Office Action Summary

10/604,061

SIROWATKA, JOHN

DETAILED ACTION

3,423,898

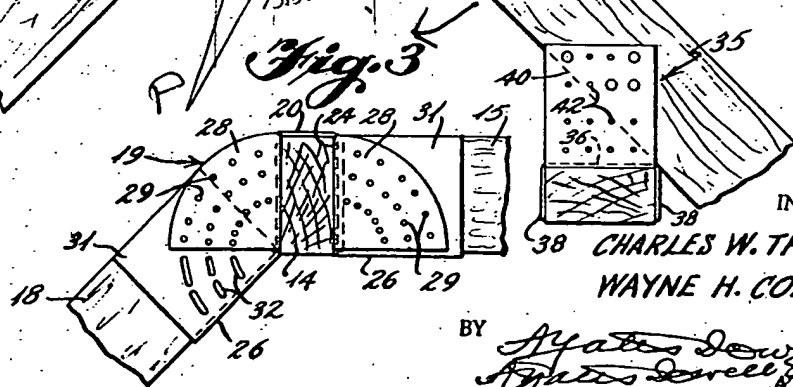
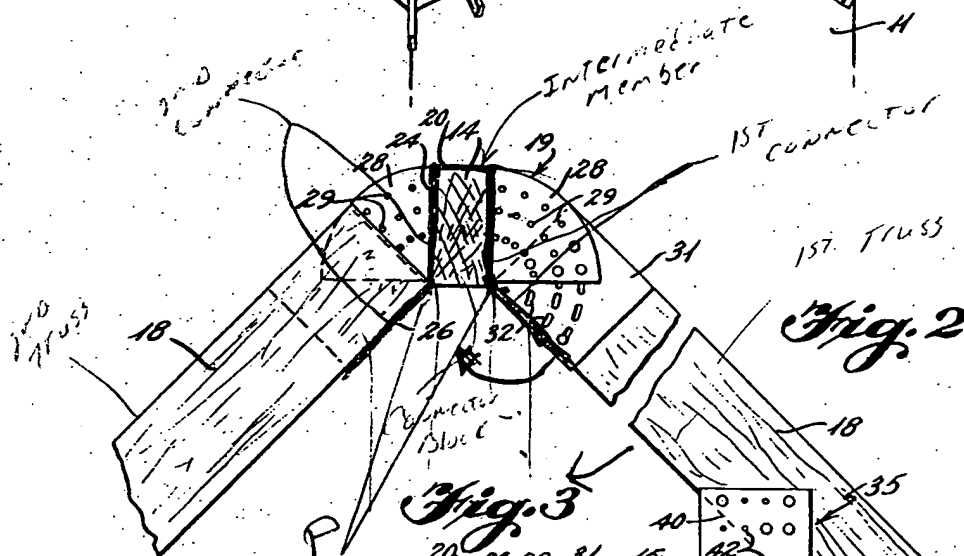
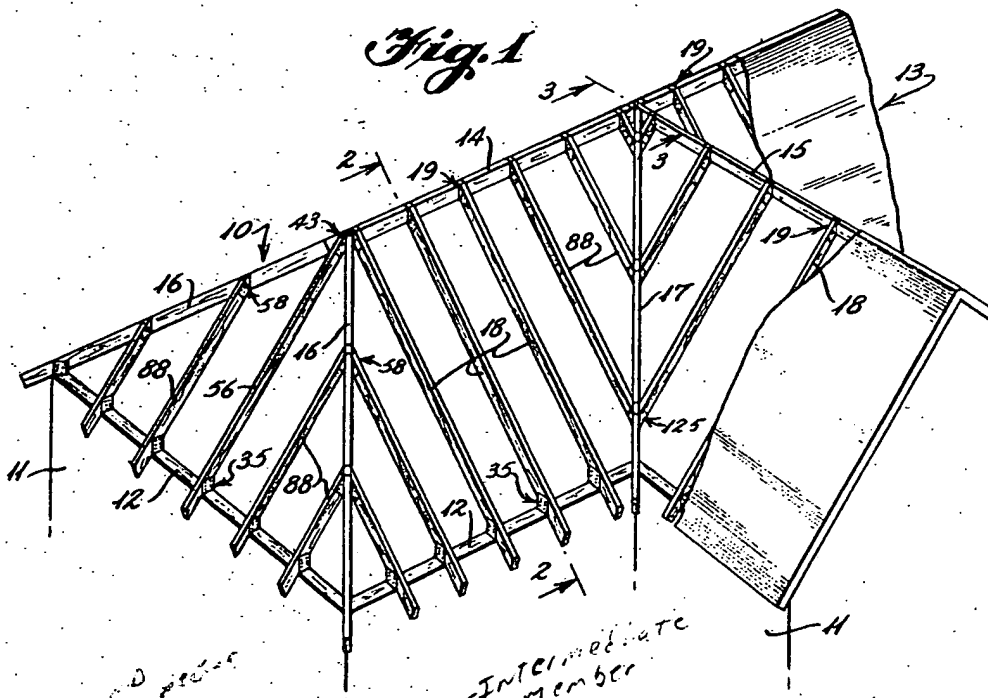
In regard to claims 10, 70: Tracy discloses the claimed invention Fig. 2, a connector and truss assembly including a first and second truss, a connector block 14 having a first end and a second end opposite from the first end, a first and second connector members 28 extending from the first end and second end of connector block 14 which pivotally attached thereto at pivot point P (see attachment) wherein the first connector member 28 is fastened by fastener 22 to the first truss member and second connector member 28 is fastened by fastener 22 to second truss member, the first truss member inherently capable of folding reversely atop of the second truss

member in direction of array (see attachment) about the respective pivotal mountings on the connector block 14.

In regard to claim 71: Tracy discloses the claimed invention Fig. 3, the first trust member has an inner and outer vertical surface 31 and second connector member 28 has outer and inner vertical member, and wherein the inner vertical surface of the first trust member and outer vertical surface of the second connector member 28 come into abutment when the first truss member is moved to a fully unfolded position with respect to the second connector member 28.
